Chapter 4. Changes

This chapter describes change from Code Generator for RL78 (CS+ for CA,CX) V2.06.00 to V2.07.00

4.1.5 Control correction of a competition pin

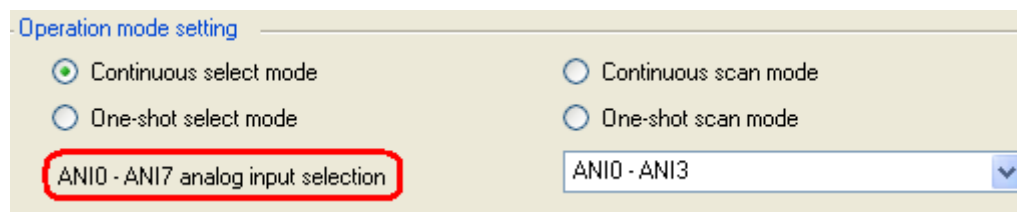
Control of the competition pin when simple-I2C of 24 and 25 pin device of RL78/G13 is set up was corrected.

Before : P17/SDA11
P30/SCL11

After : P50/SDA11
P30/SCL11

4.1.18 Changes of input pulse interval measurement of TAU

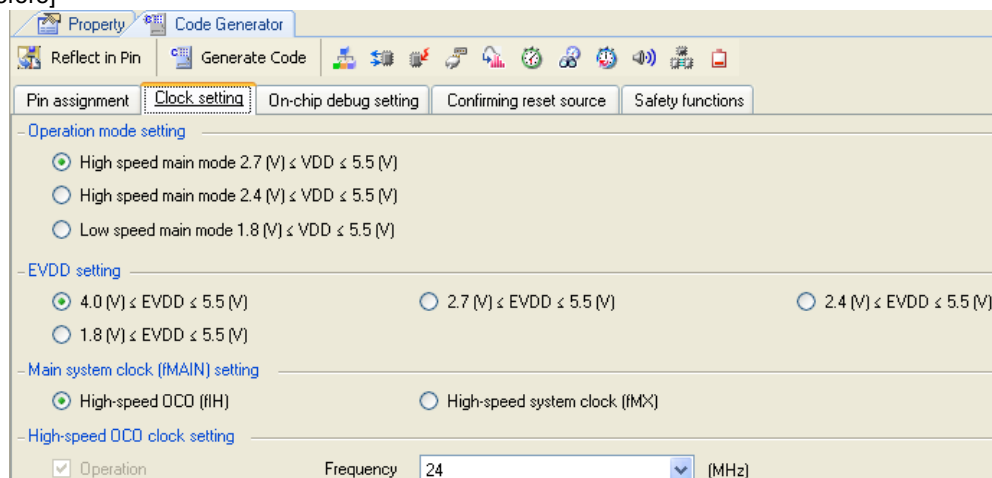
It corrected that the right measured value was not able to be acquired for the input pulse interval measurement function of TAU, and a high / low width measurement function by interruption function `r_taux_channelx_interrupt()` at the time of use.

This issue has been corrected in Code Generator for RL78,78K0R,78K0 V2.00.00.

4.1.19 Changes the notation of a power supply

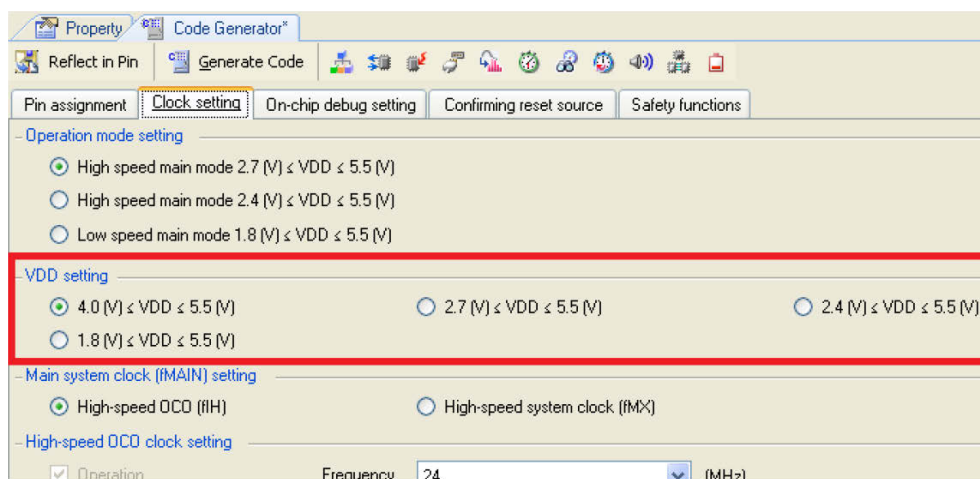
Although there was not EVDD in RL78/G12 device, it corrected that the notation remained on GUI.

This issue has been corrected in Code Generator for RL78,78K0R,78K0 V2.00.00.

5.2.8 Cautions of a setup of a real-time clock

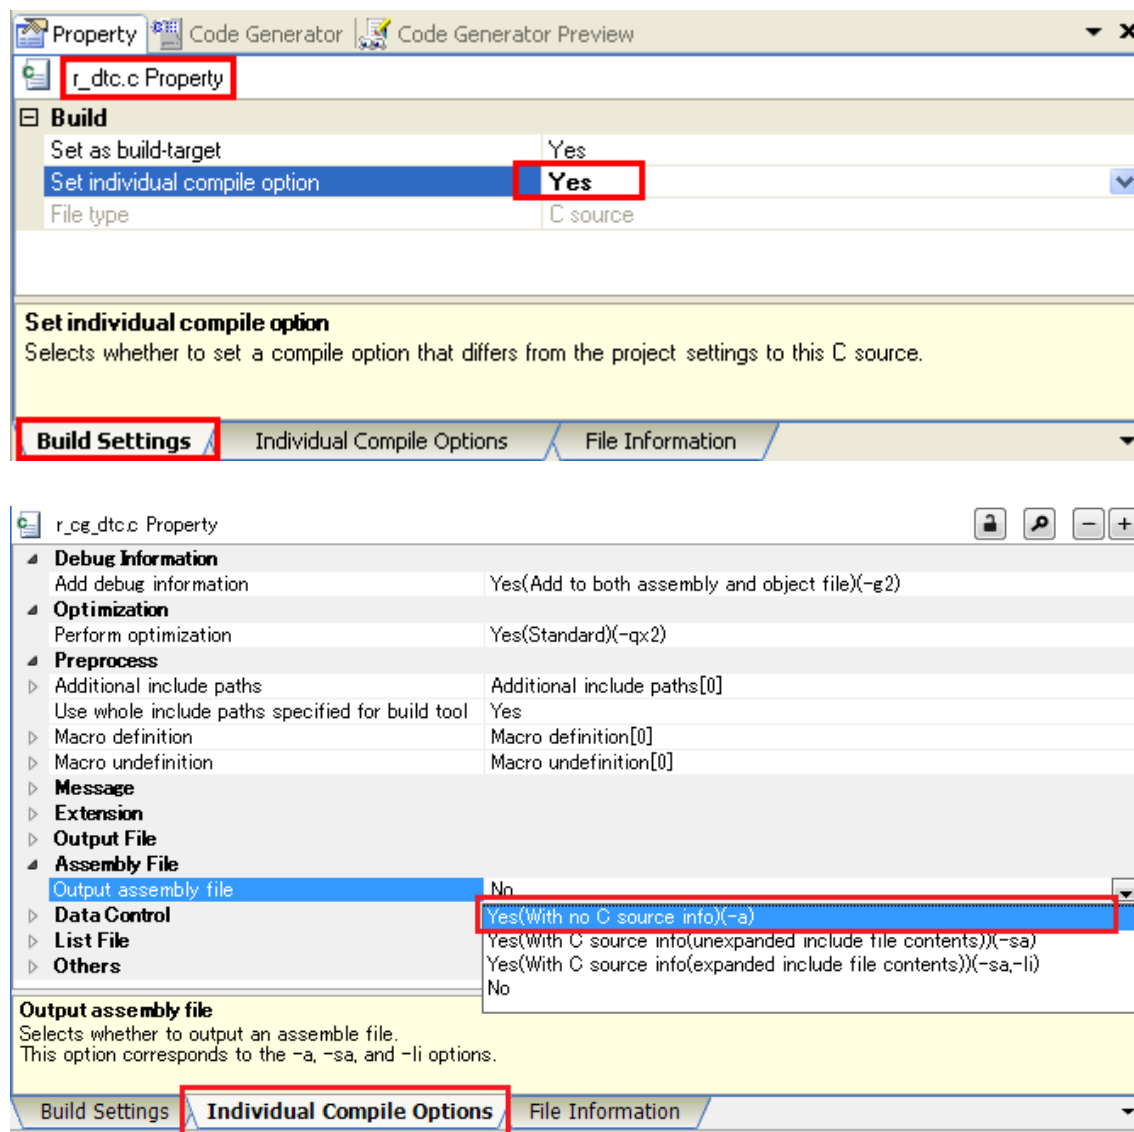
When a clock source is set to 15(fIL)kHz on device, clock function cannot be used. However, it is displayed on GUI that clock function seems to be used with 15(fIL)kHz. Please do not set up clock function.

[Workaround] RL78 Code Generator is corrected in V1.00.02.

5.2.15 Cautions of Safety Functions

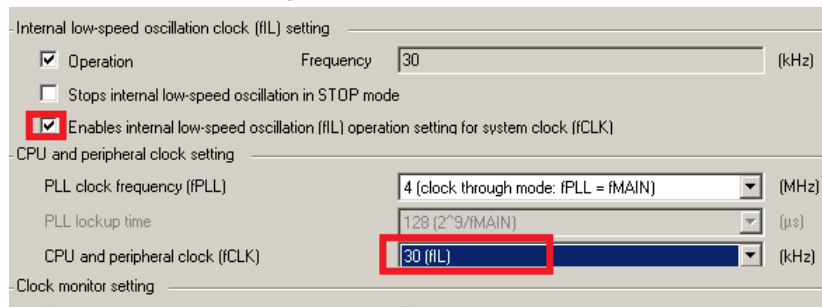
RAM parity error detection function of Safety Functions has not corresponded.

[Workaround] There is no workaround.

a) Clock

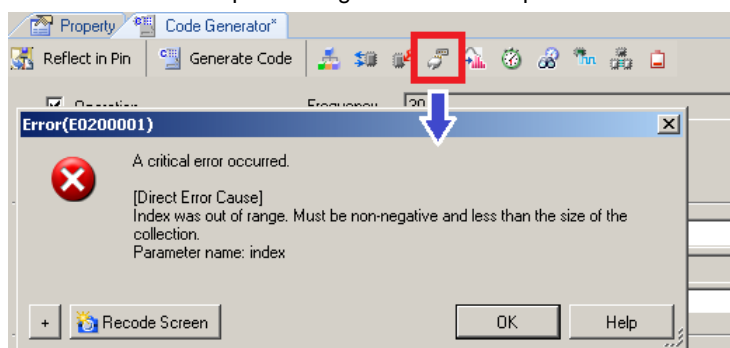
- Check in the two following items.

- Selection of a serial panel will generate an exception.

There is no workaround. RL78 Code Generator is corrected in V2.00.01

b) Timer and serial

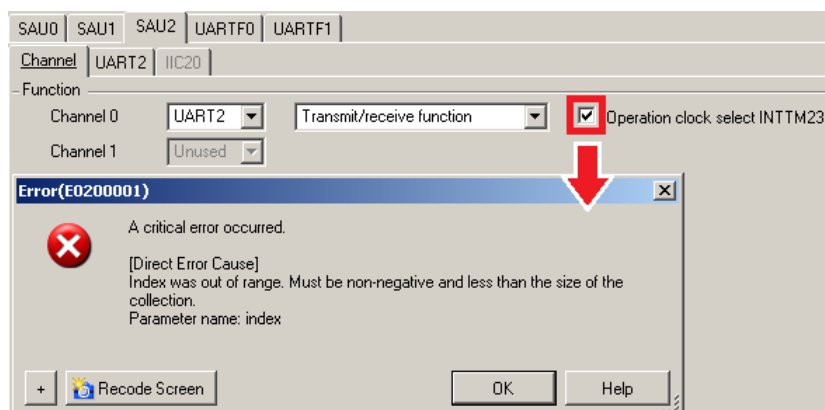
- Use interruption for the channel 3 of timer TAU2 in a certain mode.
- If a clock of operation checks one serial of serial SAU0, SAU1, and SAU2 "Operation clock select INTTM23", an exception will occur.

There is no workaround. RL78 Code Generator is corrected in V2.00.01

5.2.19 Cautions of a high-speed on-chip oscillator

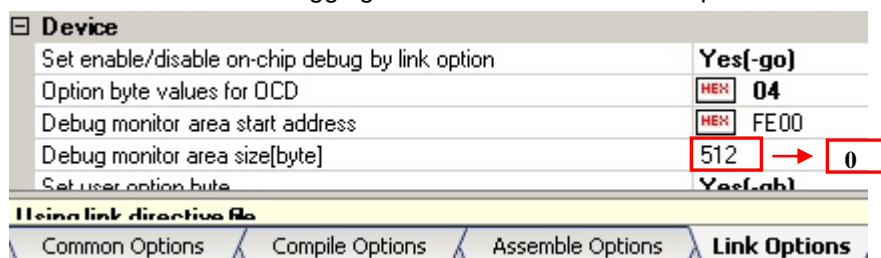
When a high-speed on-chip oscillator clock is set up by CubeSuite+ RL78, 78K0R, and 78K0 code generator V2.01.00 or earlier, If it is read by CubeSuite+V2.03.00, a clock frequency setup of a high-speed on-chip oscillator may not be right.

Please re-set up the frequency right in that case.

[Workaround] There is no workaround.
